Appendix I
Public Comments and Responses

Madera Station Relocation Project

Prepared for:
San Joaquin Joint Powers Authority

January 2021

Figure 1. A five-mile radius around Project site encompasses several neighborhoods in Madera and other communities such as Madera Ranchos.

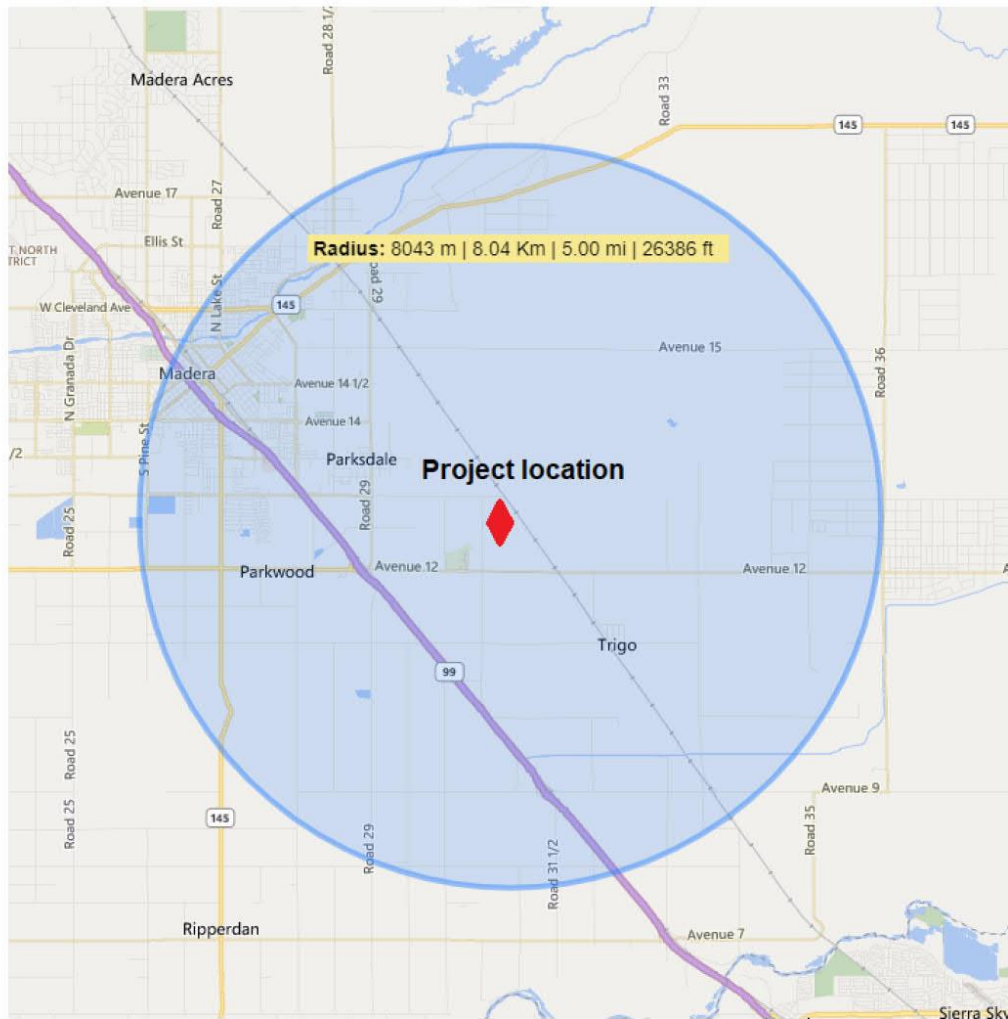
- 2-5
- 2-6 Additionally, especially with the proliferation of e-bikes⁸⁹¹⁰¹¹¹², biking is a reasonable option to destinations a bit further afield than the planned TOD district directly adjacent the Project site. As depicted in Figure 1, a decent portion of Madera is within a five-mile radius of the station which is a reasonable biking distance and especially in terms of high-speed rail, offers an extremely competitive travel time to destinations around the state such as Bakersfield, Merced, or the Bay Area. Therefore,

Additionally, especially with the proliferation of e-bikes, biking is a reasonable option to destinations a bit further afield than the planned TOD district directly adjacent the Project site. As depicted in Figure 1, a decent portion of Madera is within a five-mile radius of the station which is a reasonable biking distance and especially in terms of high-speed rail, offers an extremely competitive travel time to destinations around the state such as Bakersfield, Merced, or the Bay Area. Therefore, it would be rather advantageous to conduct additional study on what would be needed to extend low-stress bikeways out to the broader community, not limit it to the Access Road to Avenue 12.

The scope of the Project is limited to the Relocated Station and the HSR Interim Operating Segment Station, as well as providing an access road to Avenue 12. Additional studies that are outside this scope are not being considered at this time. However, as SJPA has excellent working relationships with local stakeholders, we will pass on this recommendation to our local partners for consideration.
